**Space systems — Test procedure to
evaluate spacecraft material ejecta
upon hypervelocity impact**

AMENDMENT 1: Oblique impacts and
Annex C update

Reference number
ISO 11227:2012/Amd.1:2021(E)

Figure C.3 — Sketch of target and witness plate assembly for oblique impact

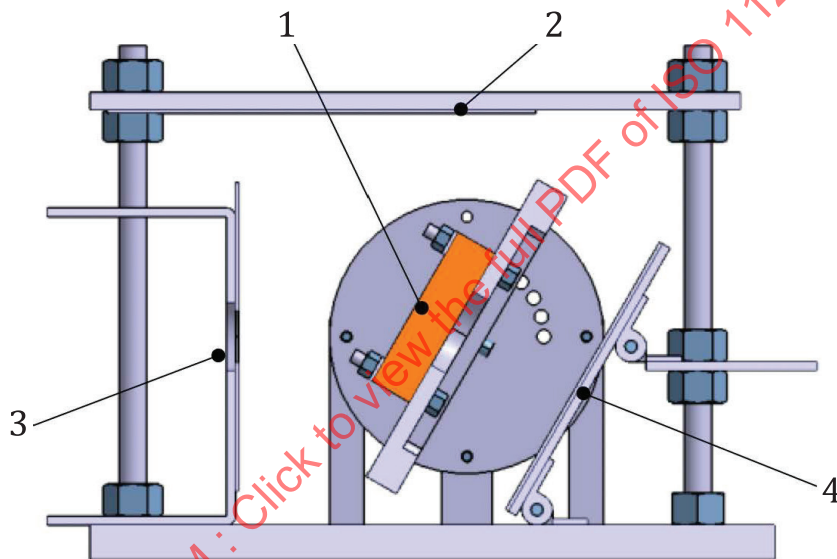
Add the following two figures after Figure C.2 and renumber the subsequent figures:

NOTE The front witness plate can be removed when the front ejecta is negligible.
